ATR on Quality Control Check Repot. (Apartments)

Flat No	A-807	QC report stage	Stage-3	Sl. No.	38435
Company	MPL	Project	MFP	Phase	-
Prepared by	Svaranjit	Sign	[Signature]	Date	27/9/24
Project Manager	Subbavardys.v	Sign	[Signature]	Date	27/9/24
Receipt by QC date	23/9/24	Sign		Other	-
Receipt at HO date		Sign		Other	
Checked By MD on		MD Sign		For filling	☐ Yes ☐ No

Quality Control Check Report. Stage: After Finishing Stage III (Apartments)

QUALITY CONTROL ELECTRICAL CHECK PLAN OF BLOCK-A TYPE-A6, A7, A8 & B5	Direction N 	Owners & Developers : BNC Estates Project Name & Phase : Miniflower Garden-Phase-I	Date : 02.12.2019 Prepared By : Shan Modi Approved By : NTS Scale :	Promoted by Modi Properties & Investments Pvt. Ltd. Phone:+91-40-66135551
--	---	--	--	--

ELECTRICAL PLAN OF FLAT-A7

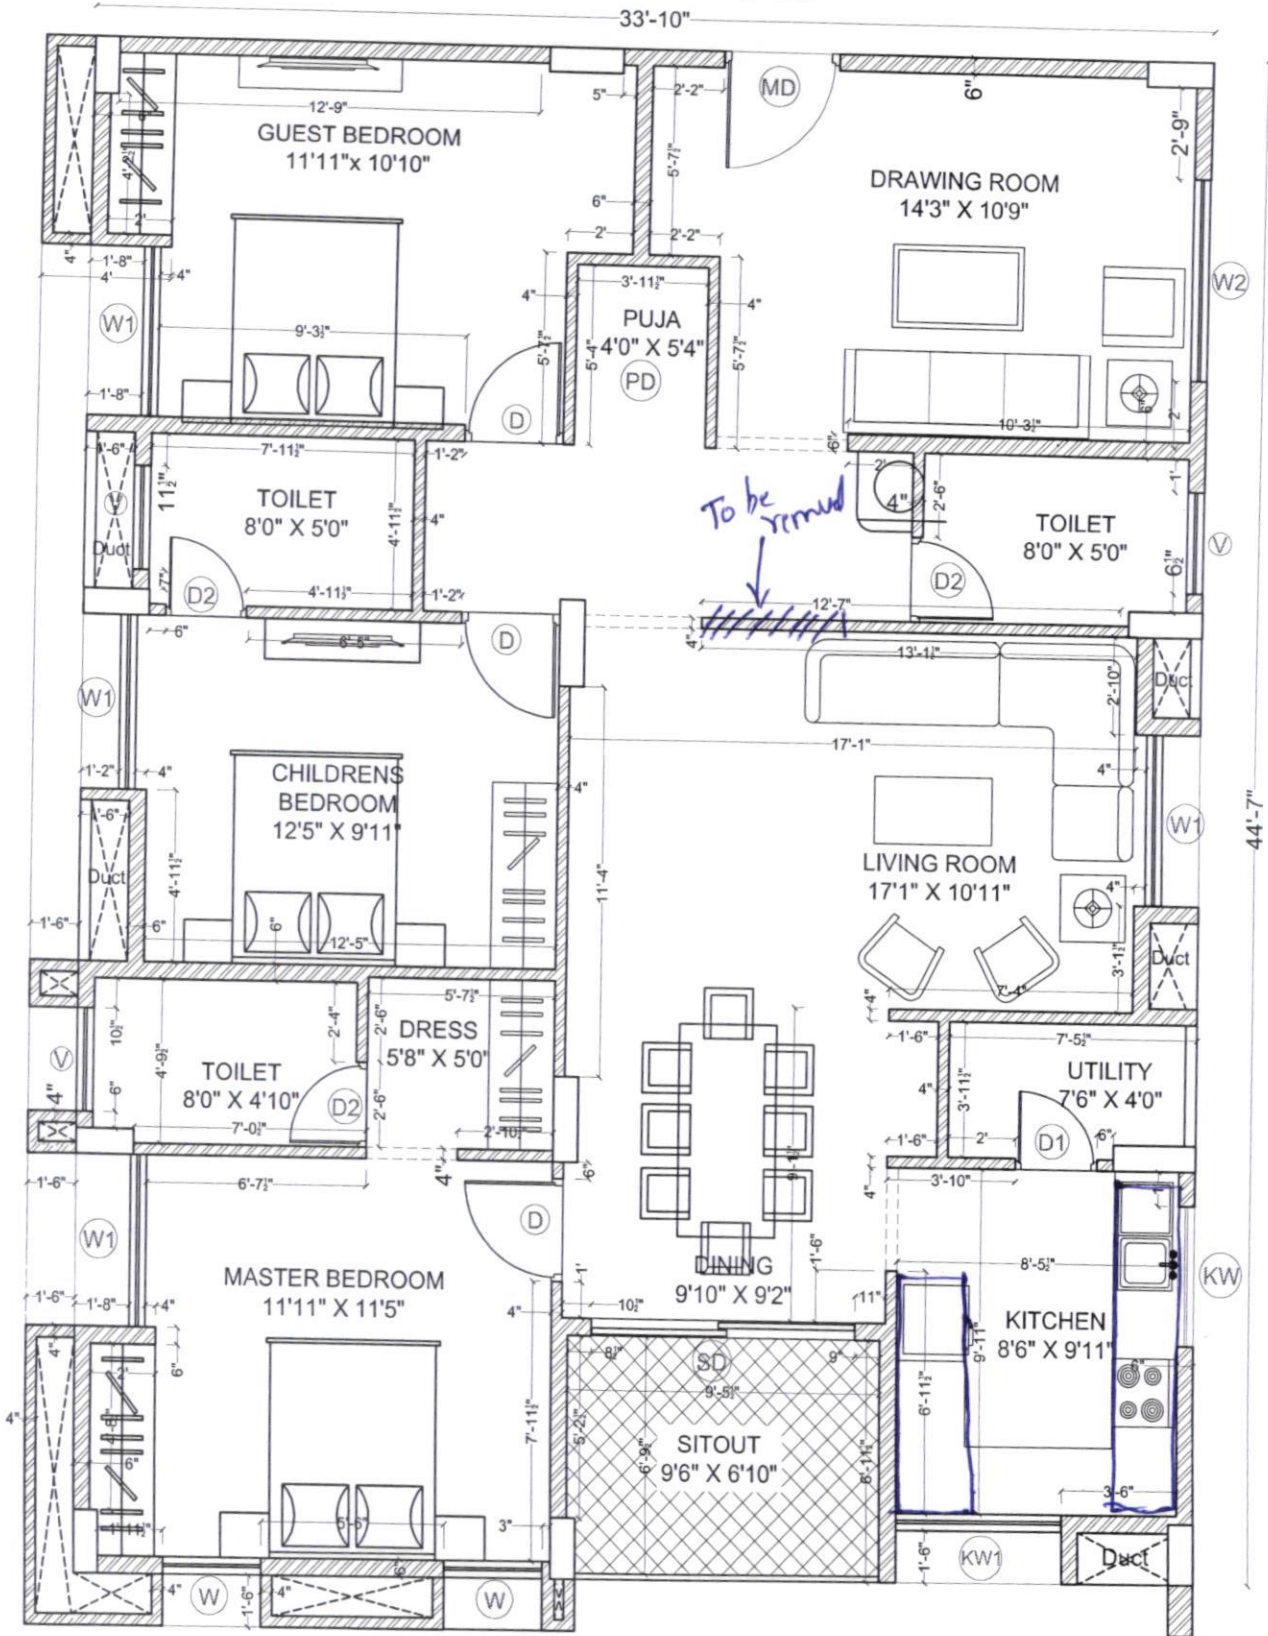
Changes in electrical points: (mark on plan)

① marked on plan

① 5amp pt in puja room

③ TV pt in drawing room

④ 15amp pt in dining area

⑤ 5amp pt in Kitchen.

⑥ Internet cable in mbr Living Room

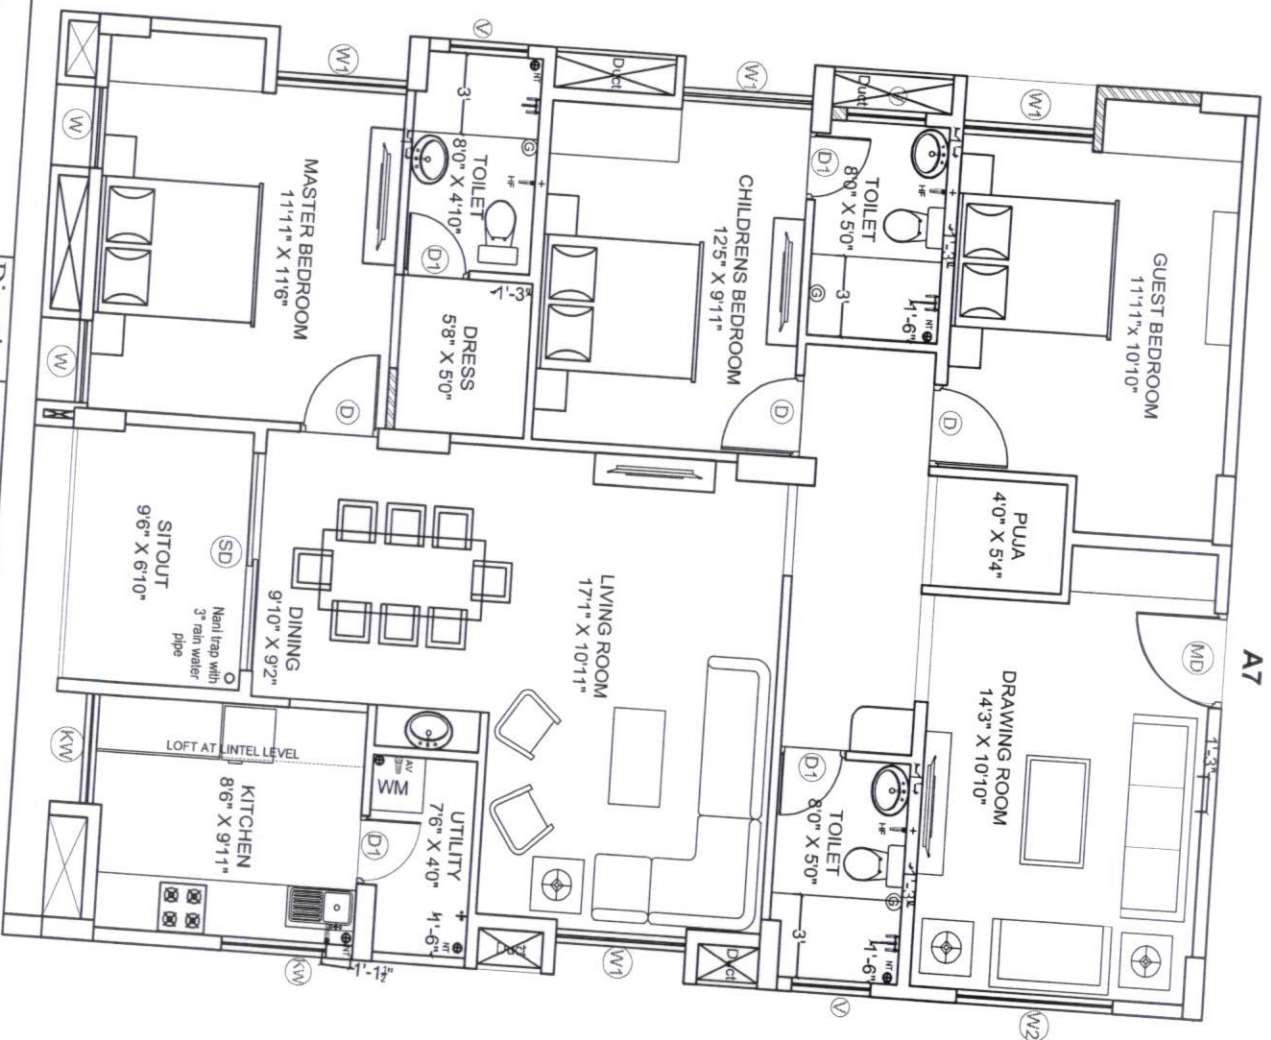
Changes in kitchen platform: (mark on plan)

① Kitchen platform extension (marked on plan)

Other Changes: ① wall to be removed between drawing & living marked on plan.

② exhaust provision in bedrooms

③ All windows - 3 track with mesh.
